BALDOR

STD HORZ 182-4T OPSB 36M SUPER-E

36LYG548

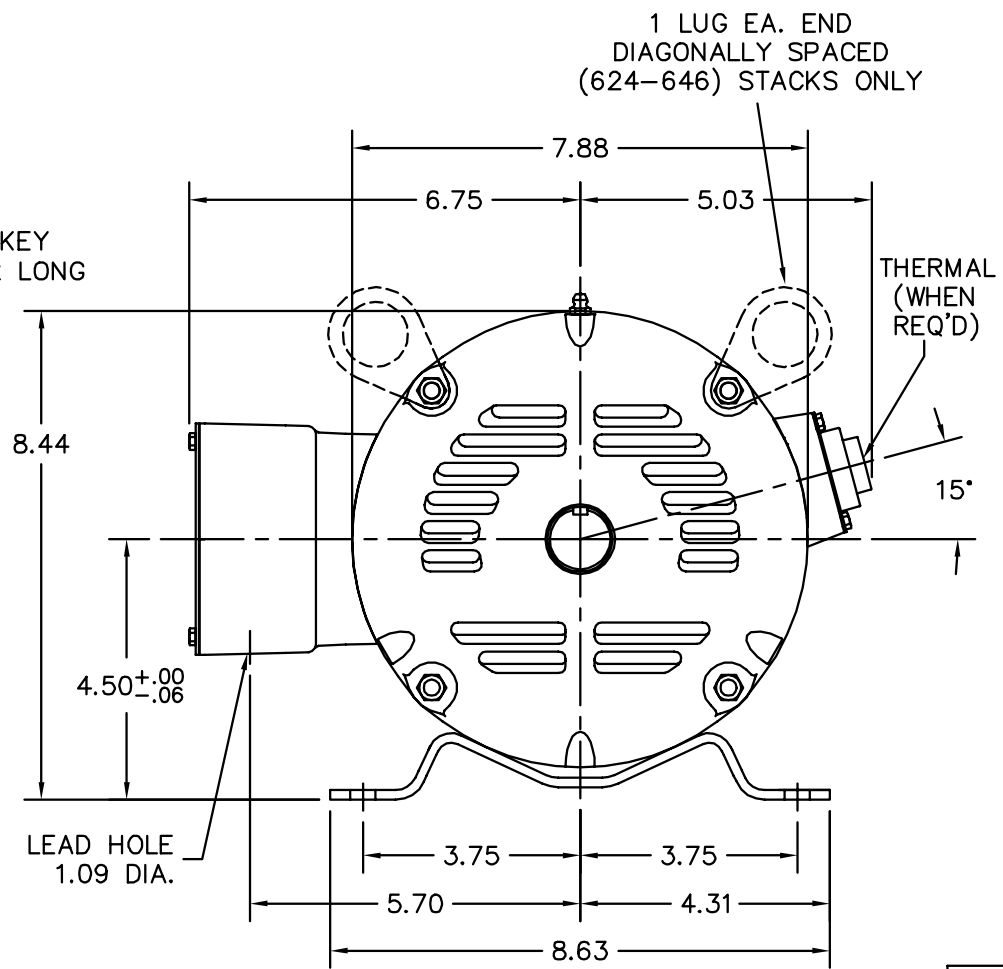
REV. DESC: CHANGE KEY LENGTH FROM 1.75 TO 2.12		
REV. LTR: F	VERSION: 03	TDR: 000001059928
FILE: \AAA\00017\098	REVISED: 08:02:57 02/06/2018	BY: ENALEMO
MTL: -

.25 KEY
2.12 LONG
